CERTIFICATE OF APPROPRIATENESS

Property: 119 North St, Lot 4, Osceola Subdivision. The property includes a historic 2,900 square foot, two-story wood frame four-plex situated on a 5,000 square foot (50' x 100') interior lot.

Proposal: Alteration – Addition

WEST SIDE ELEVATION

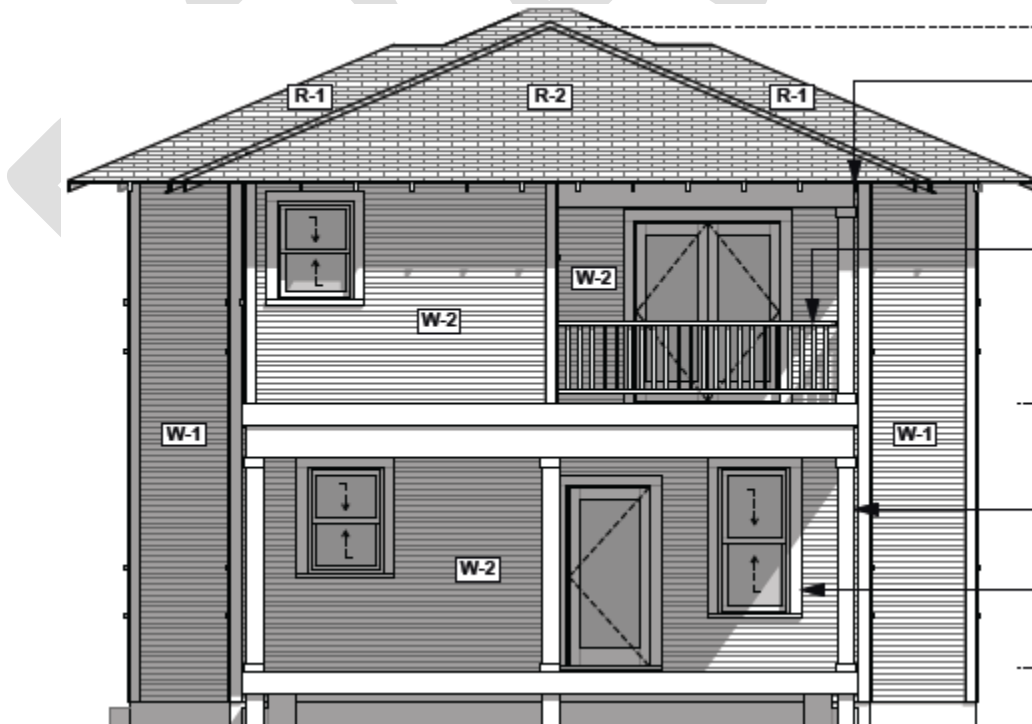
<i>The exterior features of the historic four-plex contribute to the "multi-family" character of the property. While the use of the building is changing, it should still maintain an outward appearance of a multi-family unit, which is characterized by its repeated window pattern of two larger 1/1 windows followed by one smaller 1/1 window on the side elevations.</i> |

<i>The historic building was designed as a four-plex, with identical fenestration on the first and second levels of the side elevations (two larger 1/1 windows followed by one smaller 1/1 window). While the building is being converted into a single-family residence, altering the fenestration pattern of the historic four-plex does not preserve the character of the building as a multi-family unit.</i> |

<i>The repeated fenestration pattern on the first and second levels of the side elevations is a distinctive stylistic exterior feature found on historic multi-family buildings. Altering this pattern on the west side elevation does not preserve this feature.</i> |

<i>While the applicant proposes to salvage all historic 1/1 windows on the west side elevation (either to be reinstalled on the same elevation or the rear elevation), the substantial alteration to the fenestration pattern will require extensive reframing of the wall. Relocating windows in a balloon-framed wall requires substantial demolition of the surrounding wall, along with the installation of headers at the new window locations. These alterations will result in near wholesale demolition of the existing framing and historic siding.</i> |

Under "Compatible Changes" for Windows, the Design Guidelines state: "Maintain size and location of original window openings" (p. 22). Under "Incompatible Changes" for Windows, the Design Guidelines state: "Moving original window openings is discouraged" (p. 23).

Recommendation: Approval with conditions: Retain the existing fenestration pattern on the west (side) elevation.
